Woollahra Local Planning Panel (Public Meeting)

Agenda

Figure: Section detailing HOB non-compliance – Natural Ground Level (Source: MHN Design Union/GSA Planning)

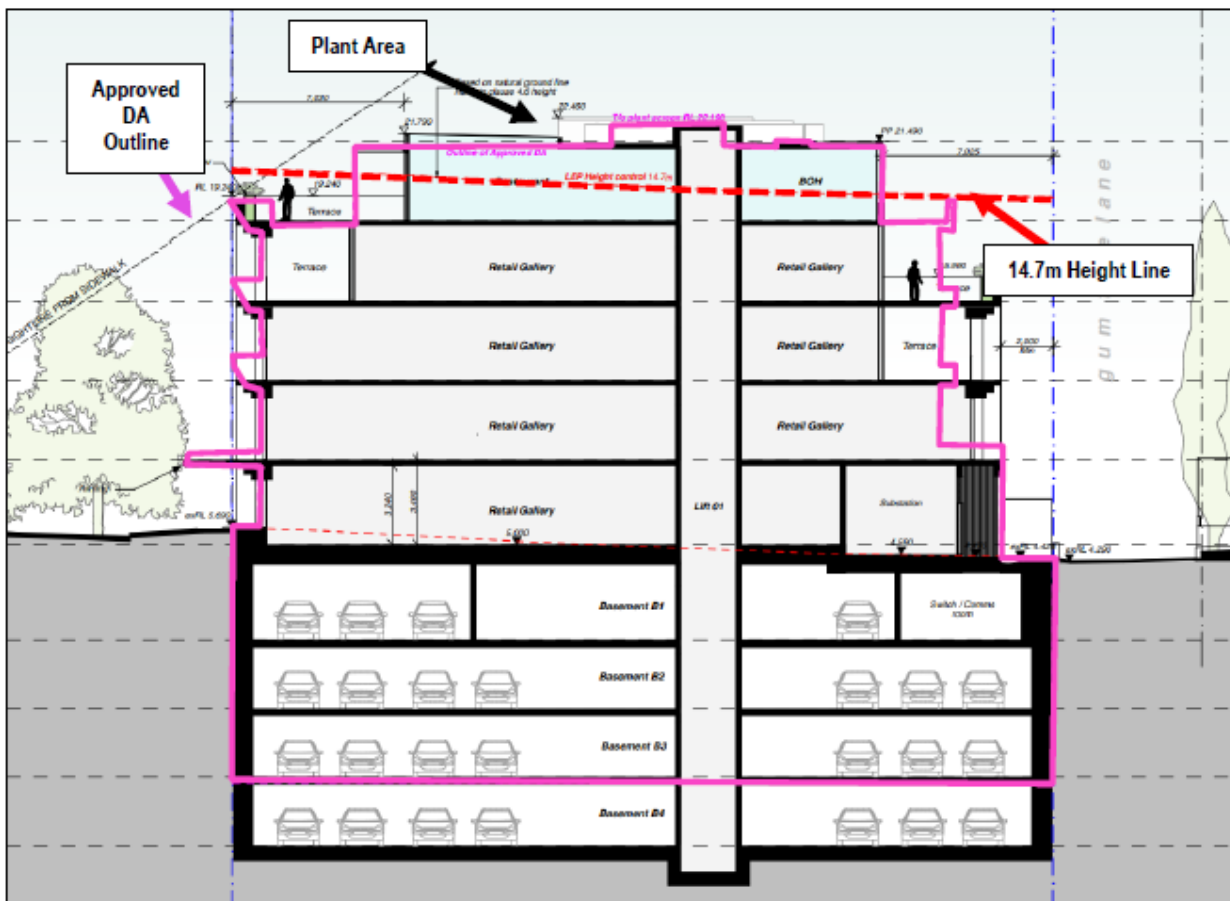
- The proposed building exceeds the 14.7m building height permitted on the eastern side of Bay Street (South) and exceeds the 2-storey (or approximate 7.4m) building height permitted above ground on the western side of Gumtree Lane, as per **Figures** above. However, the exceedance is considered to be reasonable and necessary in the circumstances of the case, as it would be consistent with the existing and desired future character of the neighbourhood as discussed in the Clause 4.6 HOB and Clause 4.6 FSR assessment of this report;

Figure: indicative diagram highlighting the potential building envelope for the site to be read in conjunction with Control Drawing 5

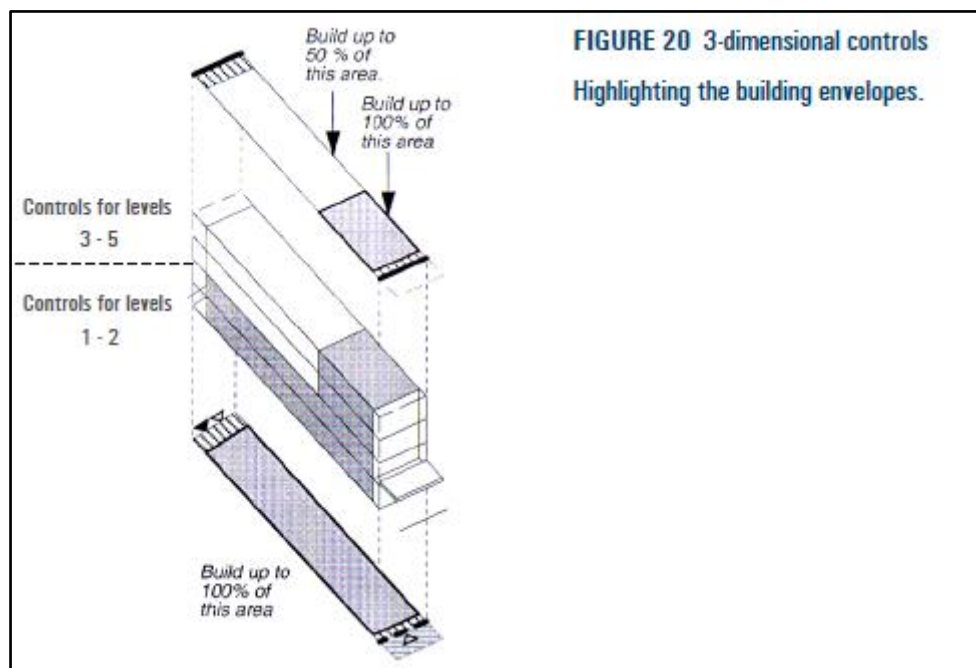
- The proposed development is beyond the prescribed building envelopes as shown on the *Built Form Envelopes: Control Drawing 5* and as noted in the Compliance Table above;

Figure: Diagram in Part D5.6.4.3 specifying specific sites in the centre with desirable through block connections (subject site highlighted).

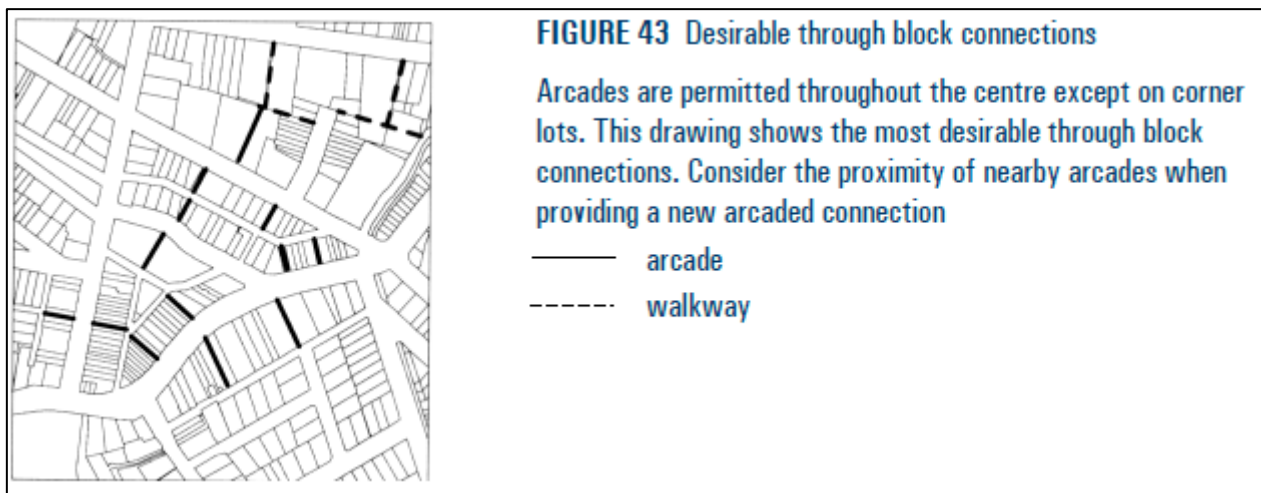
Per **Figure** above (Figure 43 in the DCP) and Control Drawing 5, a through block connection via an arcade is encouraged and as a desirable location through the site from Bay Street to Gum Tree Lane.

Figure 3 – Level 4 Plan – DA 2009

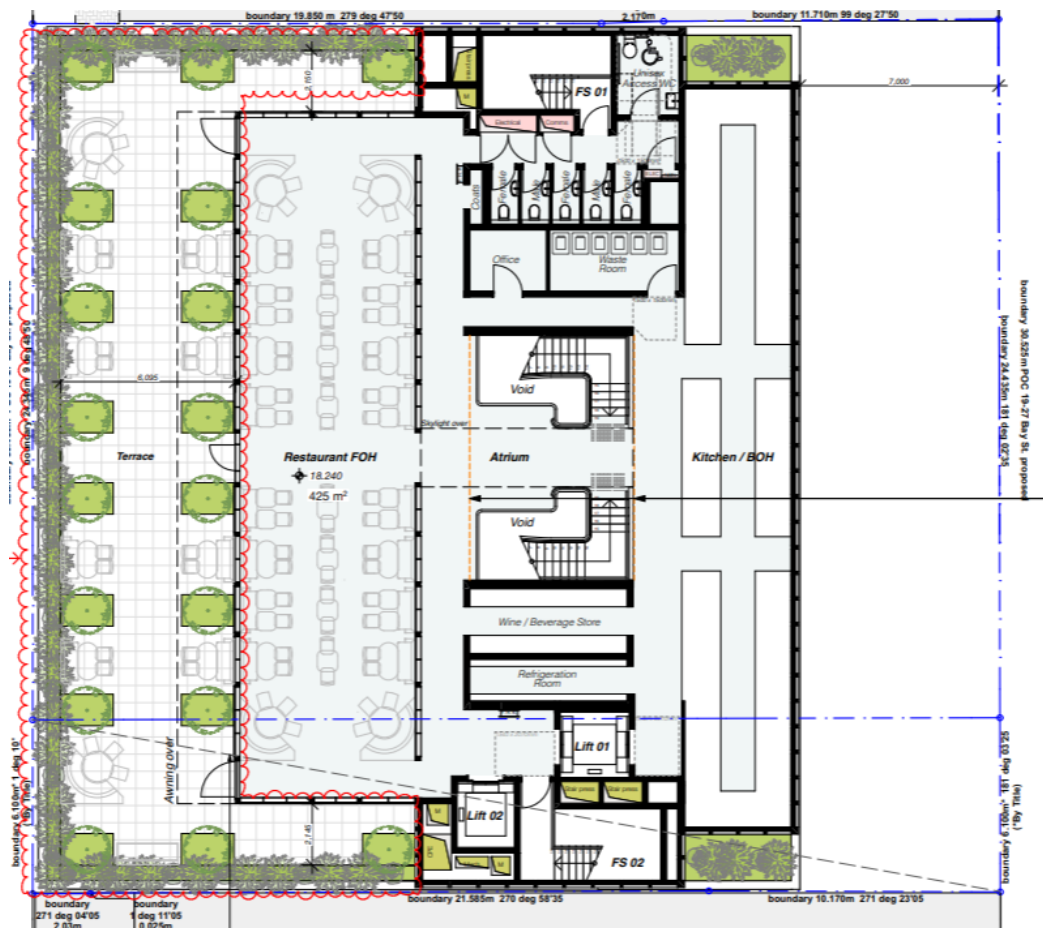
The 5th floor is recessed 7.98m from Bay Street and 6.9m from Gumtree at the upper level

Figure 4 – Control Drawing 5

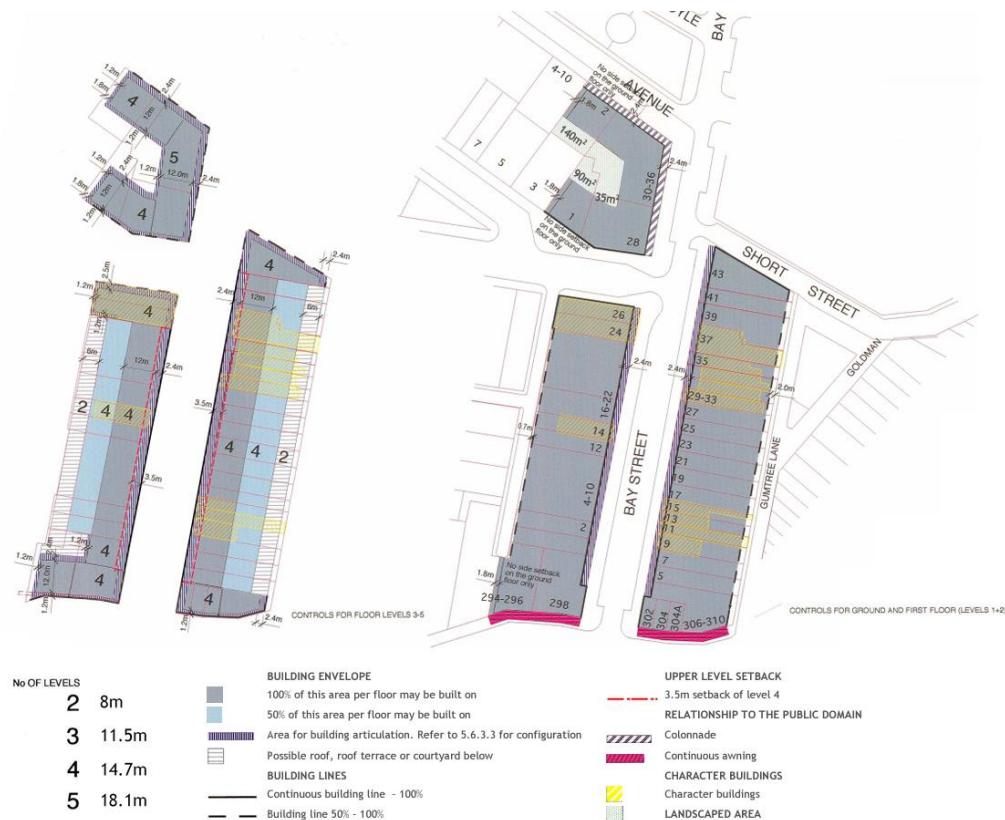
D.5.5.9 - Control Drawing 5

Figure 5 – East Elevation DA2402

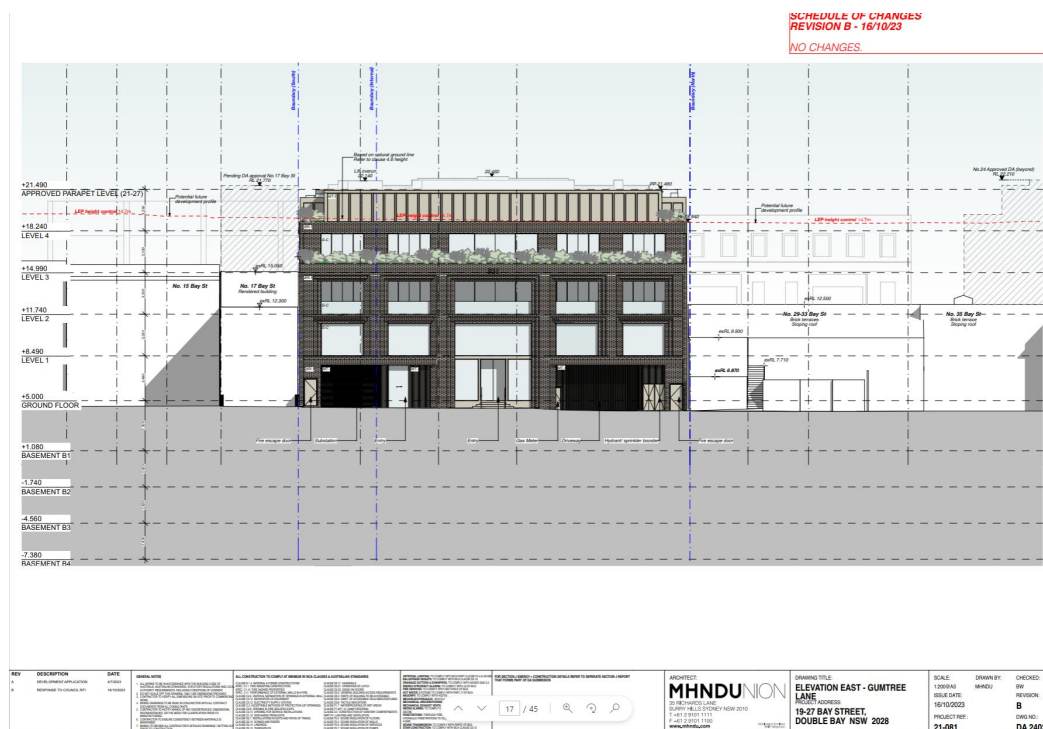
The proposal will have a three-storey street wall addressing Gum Tree Lane.
